**Communication for 11, 31, and 51 Woodend Place (files OP.16.003, Z.15.032 and 19T-15V011) – Public Hearing date May 3, 2016**

Re: **Country wide Homes Woodend Place Inc.**  
**11, 31, 51 Woodend Place**  
File name: **Countrywide Homes Woodend Place Inc.**  
File numbers: **Z.15.032, 19T-15V011 and DA.15078**

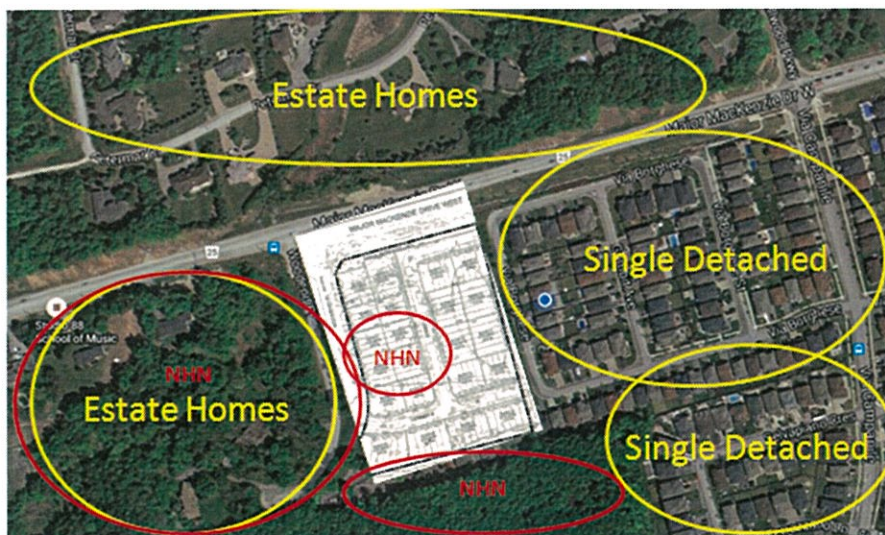
Rendering of proposal (three story townhome inconsistent with community and surrounding neighbourhoods; completed towns within immediate area have increased over 284% since 2006 (per York Region Traffic Zone data) adding adequate inventory, intensification and diversity (does not include additional towns &/or apartments that have been approved or are currently under construction; further, proposal does not protect existing NHN)

Aerial I view of surrounding area (does not maintain consistency...at all!)

**ZONING MAP FOR CONTEXT :**

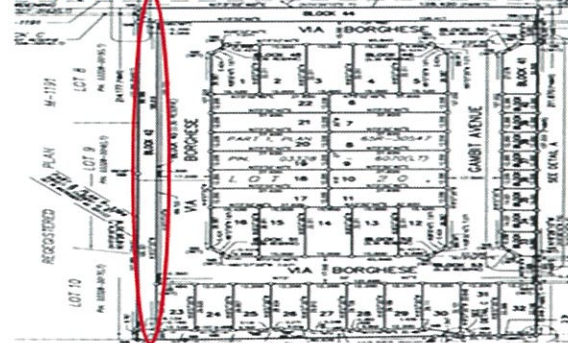
The subject lands (11, 31 and 51 Woodend Place) are zoned **RR Rural Residential Zone** by Zoning By-law 1-88. Section 4.2 clearly defines uses permitted as **Single Family Detached Dwelling**.

Block 42, Plan 65M-4149, are zoned **RD2(H) Residential Detached Zone Two** (with a Holding Symbol "H" subject to Exception 9(1281) by Zoning By-law 1-88). Section 4.24 clearly defines uses permitted as **Single Family Detached Dwelling**.

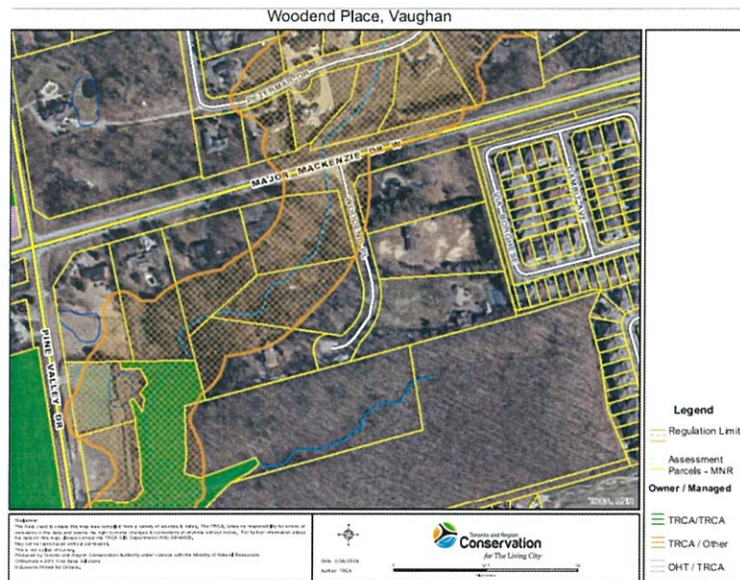
Another important consideration in completing this analysis was the care, or lack thereof, given to the natural environment. Accordingly, the Ontario Ministry of Natural Resources and Forestry (Aurora District) was engaged to speak to how the subject proposal impacts **Areas of Natural and Scientific Interest (ANSI)**. The below image was provided and outlines the categorized lands. While not directly impacted, it is expected any eventual development will adequately account for maintaining its environmental importance.

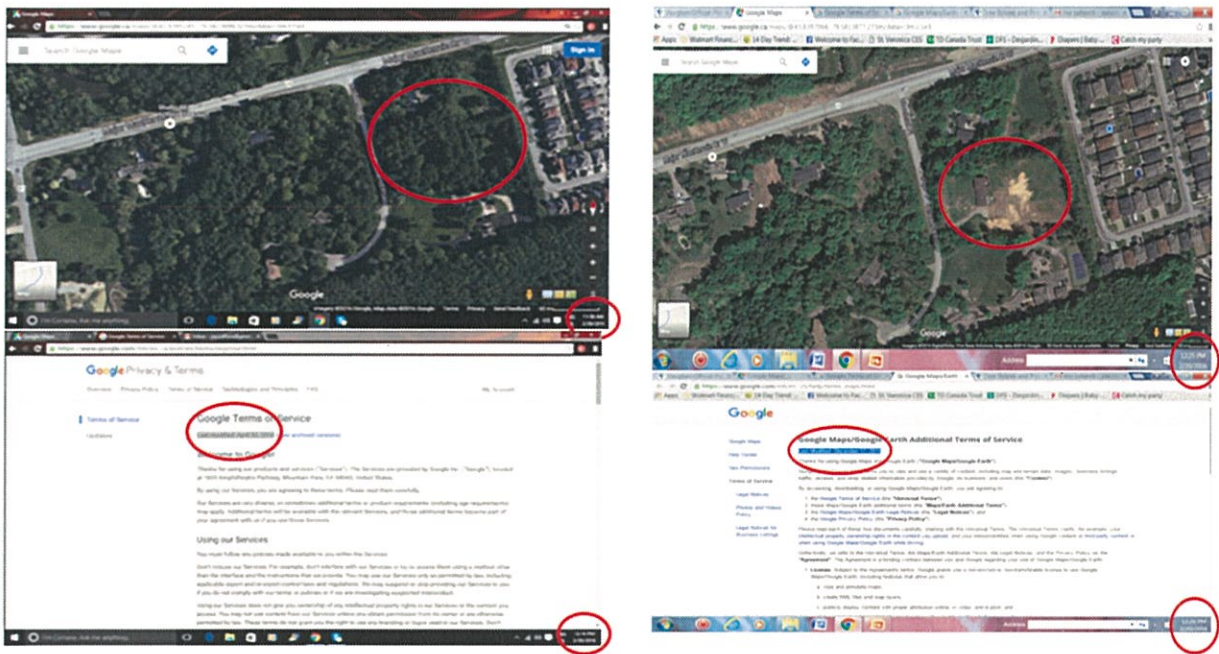
Finally, City of Vaughan Planning and Environmental services officials were engaged to validate the **Natural Heritage Network** implications including any existing **Core features**. The following images confirm the proposed development does in fact impact the existing features including the removal of an entire woodlot that remains under investigation:

What is of particular interest, aside from the questionable manner an entire woodlot was removed, is the fact that during the current review of the Natural Heritage Network, the subject woodlot was reaffirmed as a Core Feature and as such every effort should be made to preserve the inherent value, ecological features, biodiversity & connectivity of these natural features. Through the course of our ongoing investigation into this matter, via the Municipal Freedom of Information and Protection of Privacy Act, we will review the details of any claim, the timing of the claim, the manner in which it was dealt with and approved including any applicable arborists report. In addition, a compensation plan for any trees found to have been removed negligently will be expected and any proposed development halted per Chapter 3, section 3.2.3.9 of the VOP.

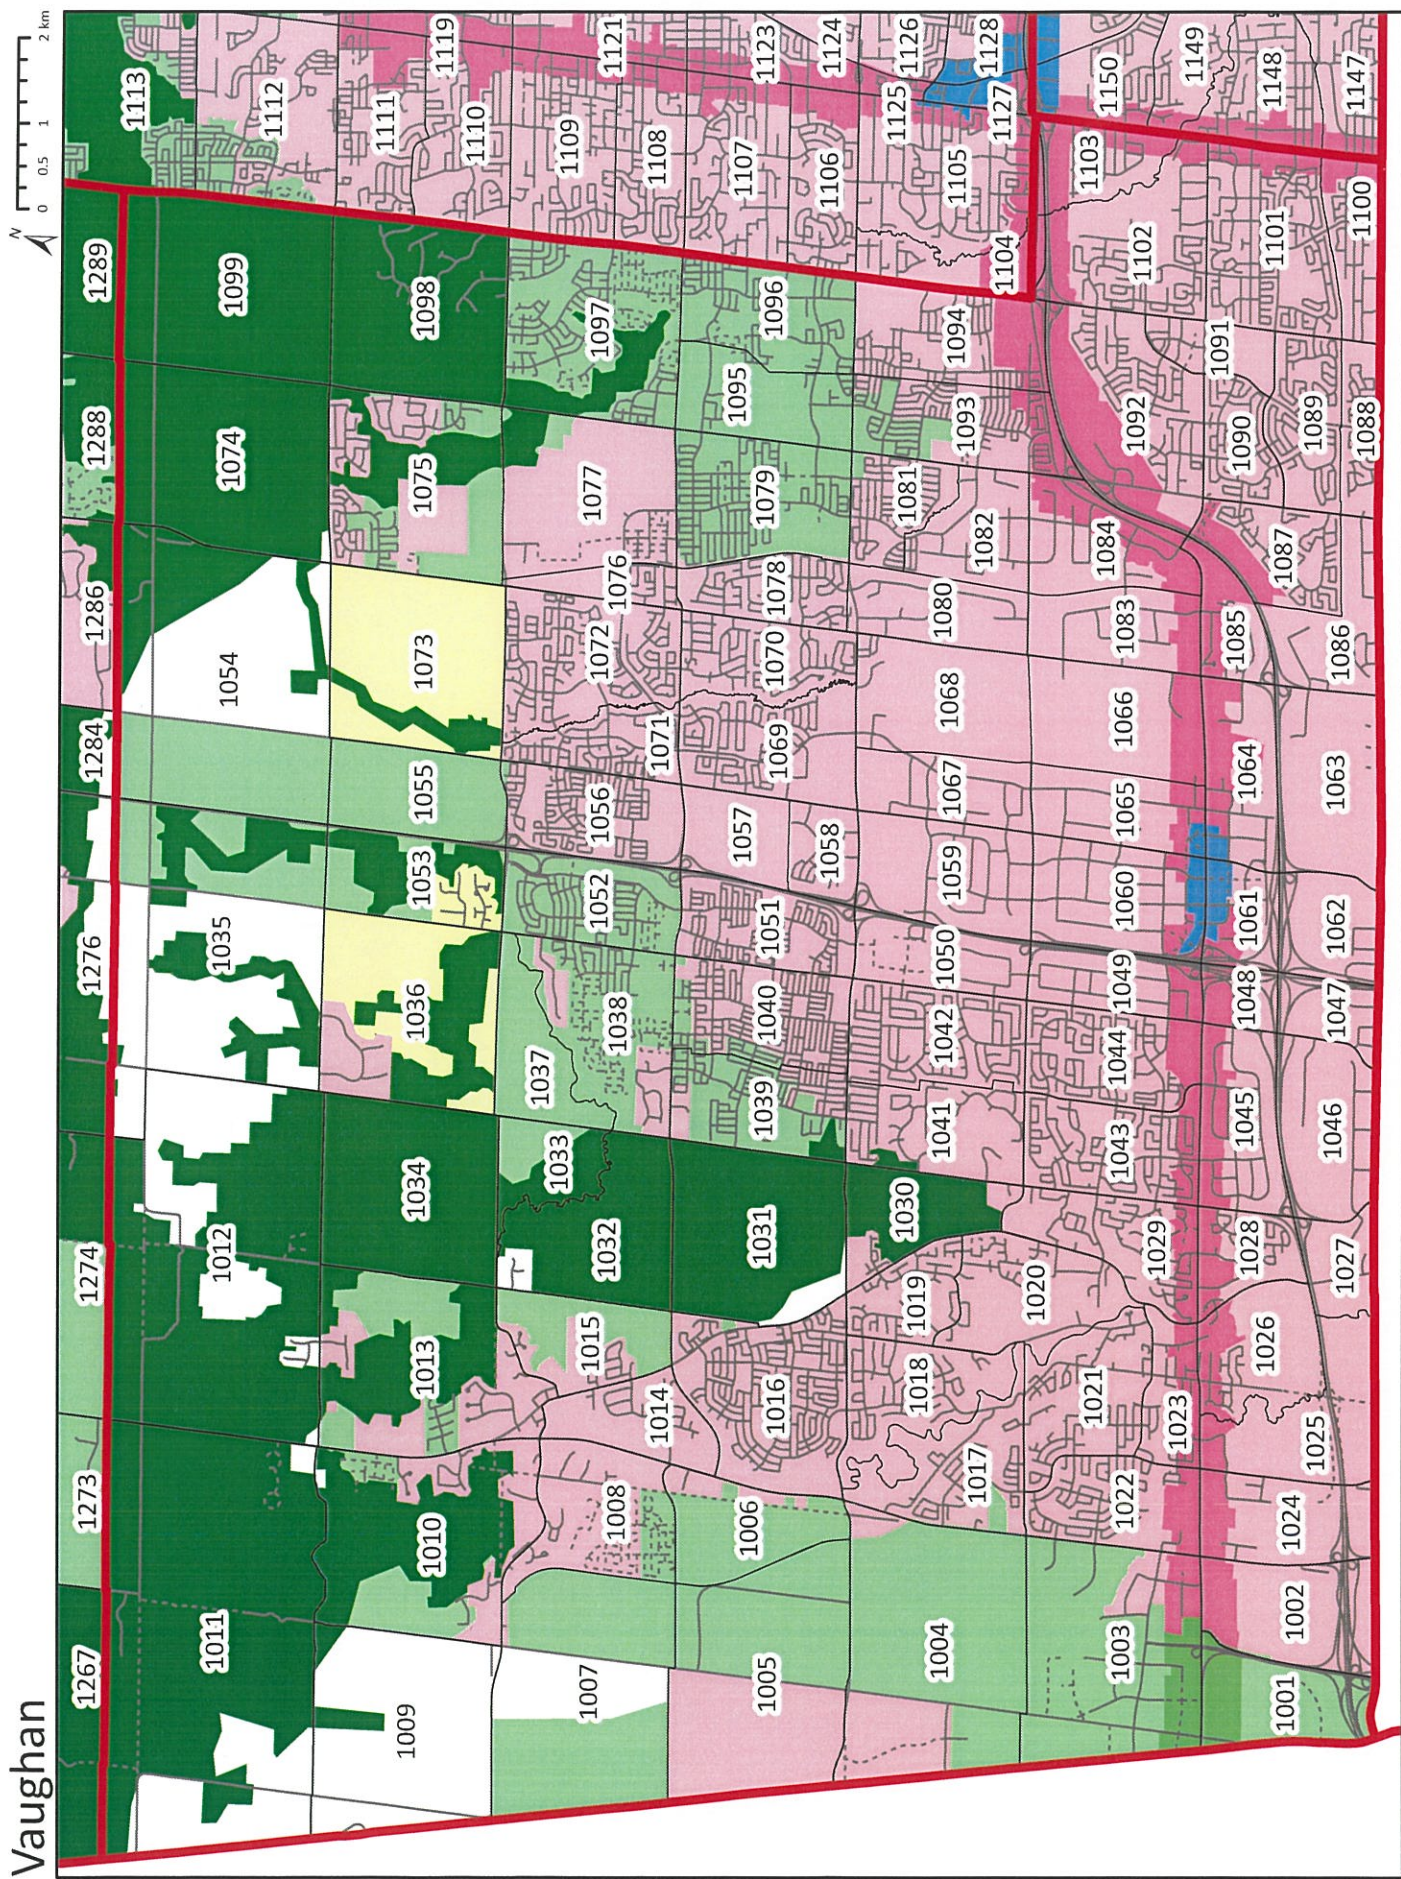
Considering the vast lands available within the subject area, the below image demonstrates how potential development may be considered. If the City of Vaughan's Intensification target of 45% is applied to the existing community (i.e. 3 homes), it would only require one single detached home be added. That said, and with the greater needs of Vaughan in perspective including supporting reasonable growth, **a community of 80' (foot) lots can be effectively developed** which would add reasonable density and would not adversely impact the immediate area. This would maintain consistency of the surrounding communities, would not require significant zoning deviation, address environmental issues and would be closely aligned with the spirit of the VOP.
